**ADDENDUM NO. 03**

Project: Ridgeview Elementary School  
701 Thornton Street, Liberty, Missouri 64068

Project No. 23026

## **ADDENDUM NO 03**

A681

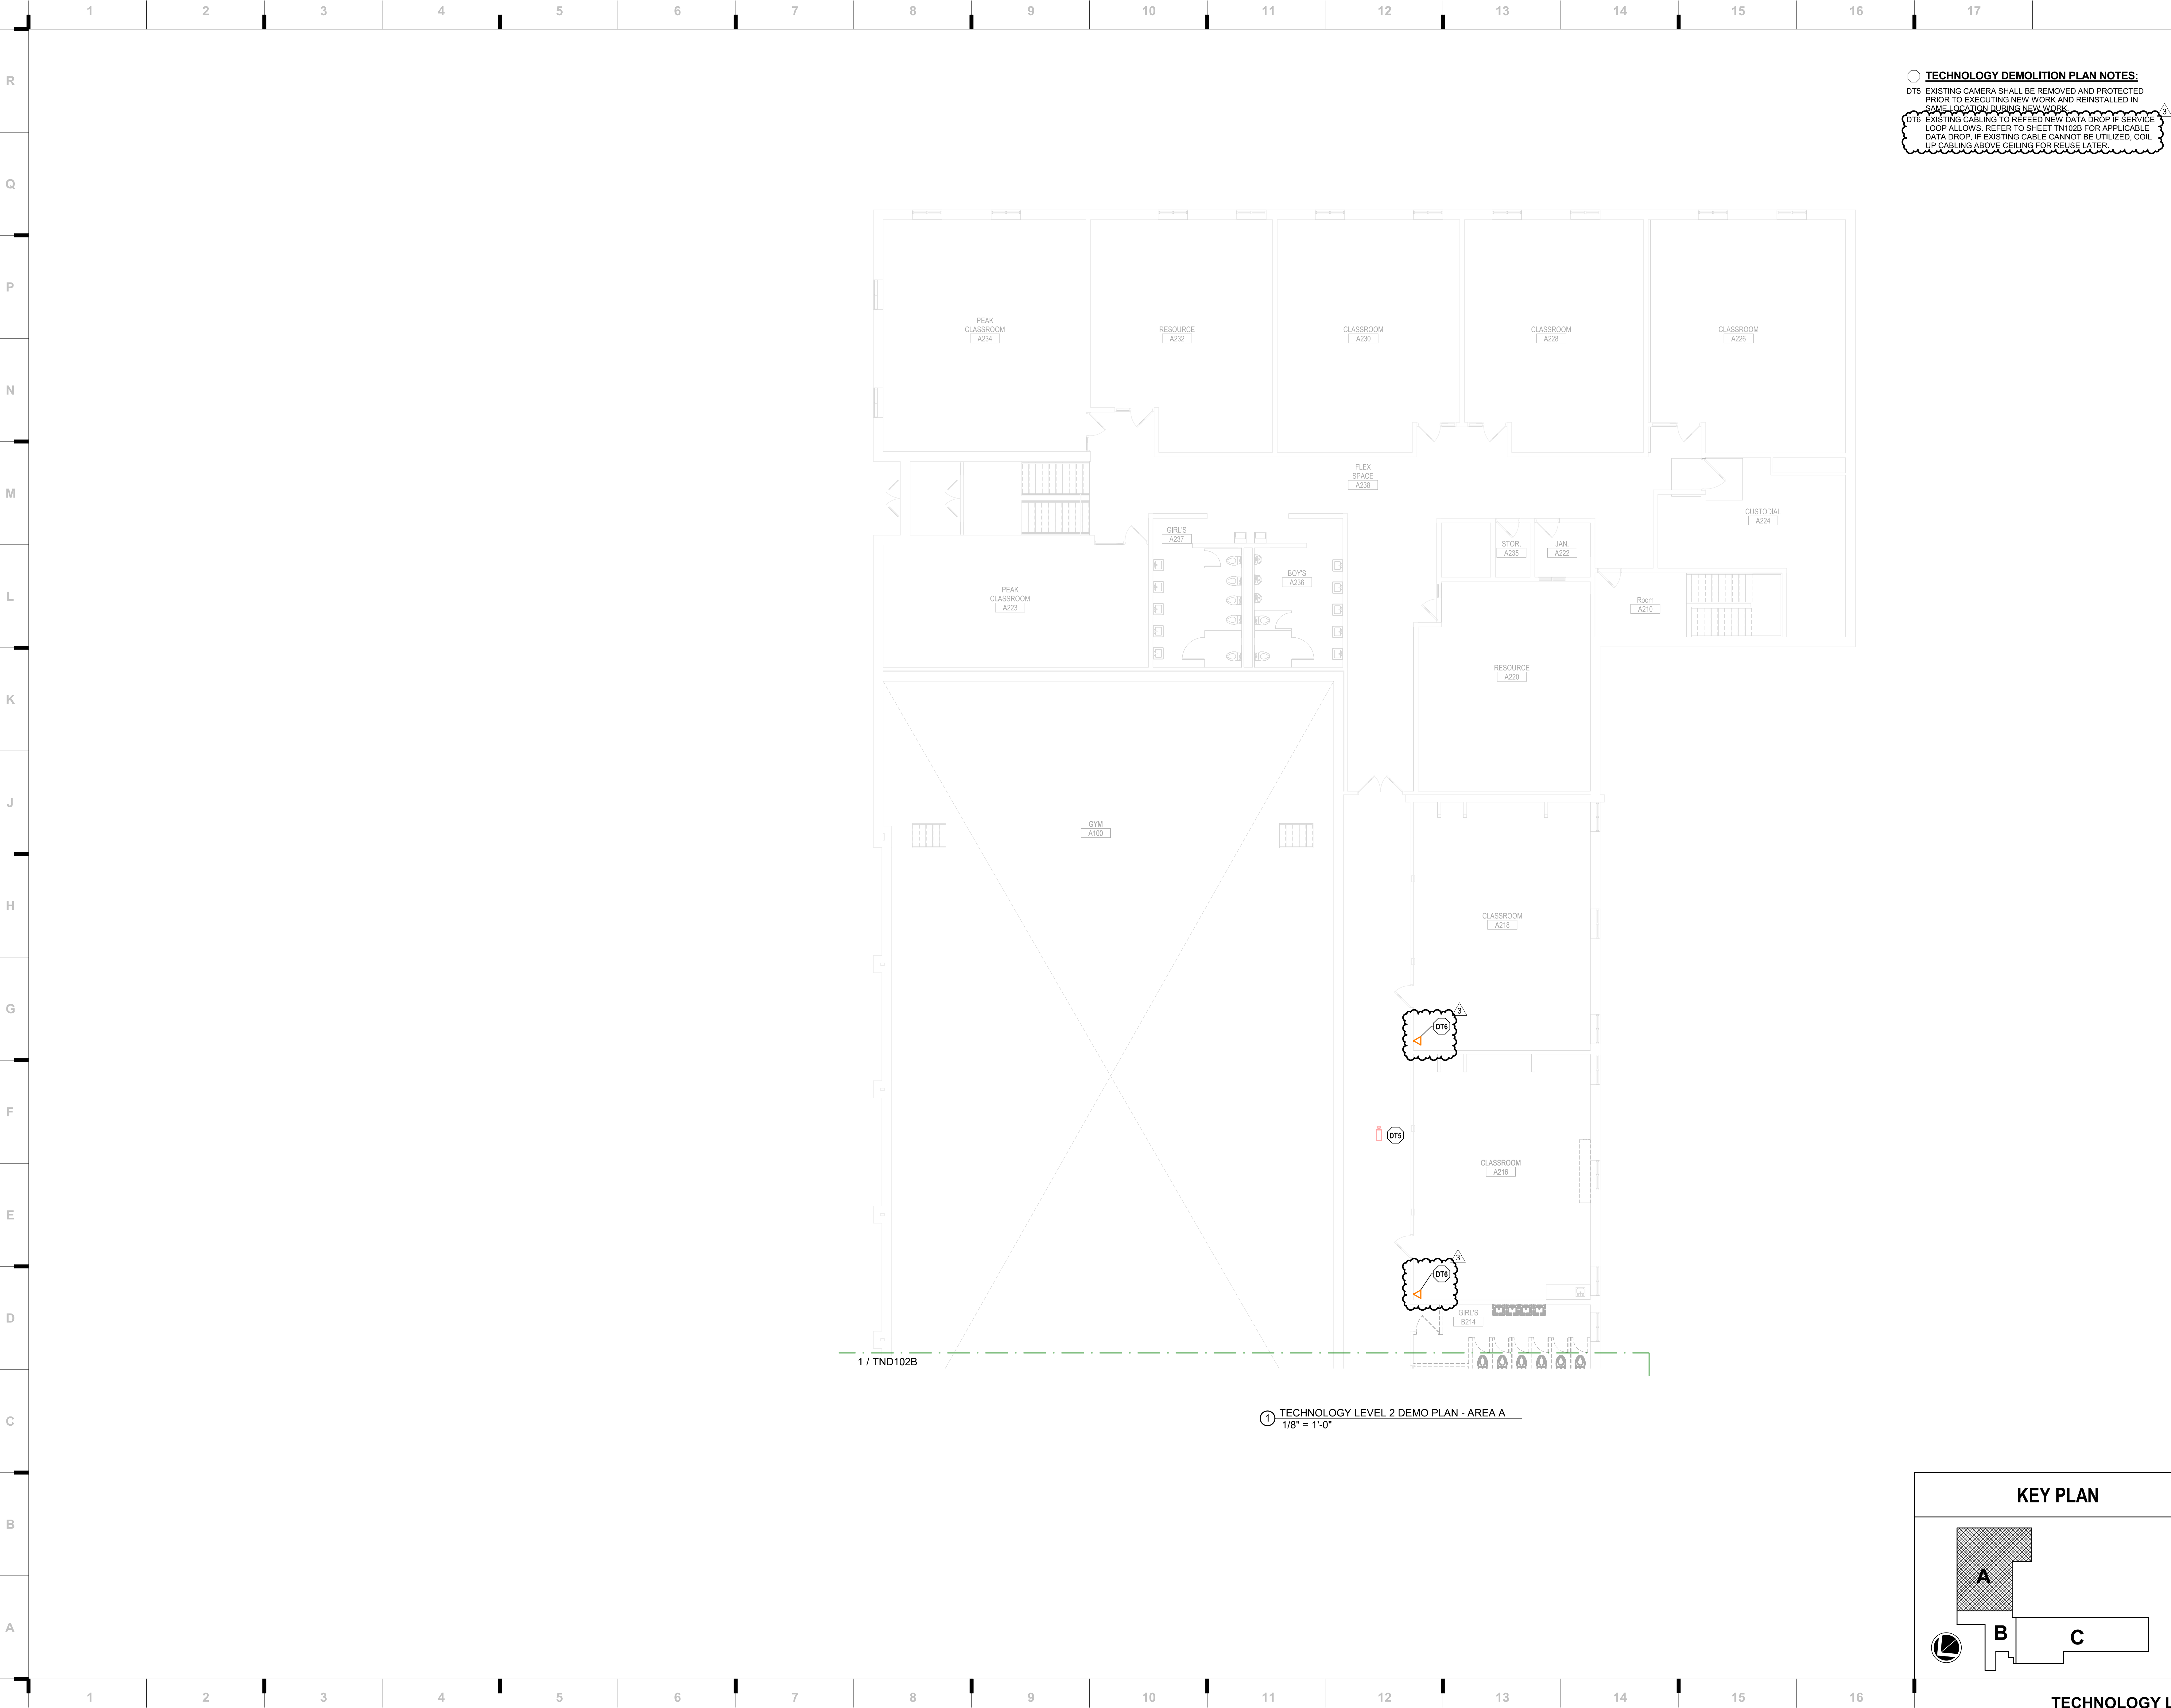
A1.1 ADDED Storage B221a to Room Finish Schedule

**TND102A**

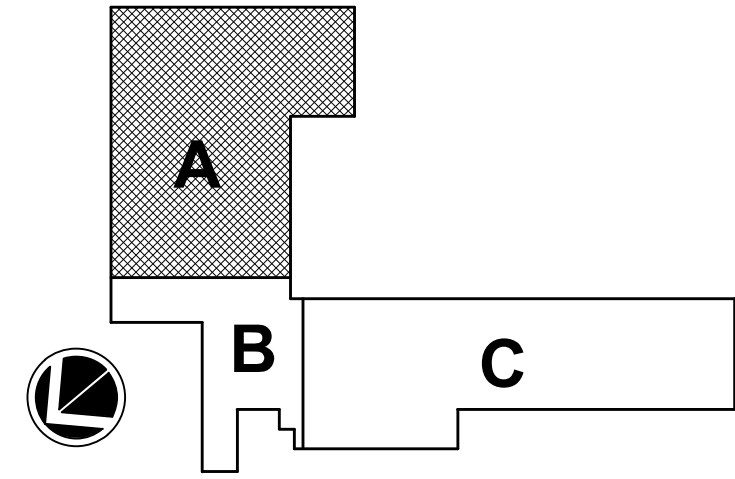
1. Sheet TND102A – TECHNOLOGY LEVEL 2 DEMO PLAN – AREA A
  - a. Added note to reland cabling to new device if service loop allows and to coil up cabling above ceiling if service loop isn't sufficient.
2. Sheet TND102B – TECHNOLOGY LEVEL 2 DEMO PLAN – AREA B
  - a. Added note to reland cabling to new device if service loop allows and to coil up cabling above ceiling if service loop isn't sufficient.
3. Sheet TN102A – TECHNOLOGY LEVEL 2 PLAN – AREA A
  - a. Added note to reland cabling to new device if service loop allows and to provide new cabling if service loop isn't sufficient.
4. Sheet TN102B – TECHNOLOGY LEVEL 2 PLAN – AREA B
  - a. Added note to reland cabling to new device if service loop allows and to provide new cabling if service loop isn't sufficient.

**TECHNOLOGY DEMOLITION PLAN NOTES:**  
DT5 EXISTING CAMERA SHALL BE REMOVED AND PROTECTED PRIOR TO EXECUTING NEW WORK AND REINSTALLED IN SAME LOCATION DURING NEW WORK.  
DT6 EXISTING CABLEING TO REFEED NEW DATA DROP IF SERVICE LOOP ALLOWS. REFER TO SHEET TND102B FOR APPLICABLE DATA DROP. IF EXISTING CABLE CANNOT BE UTILIZED, COIL UP CABLEING ABOVE CEILING FOR REUSE LATER.
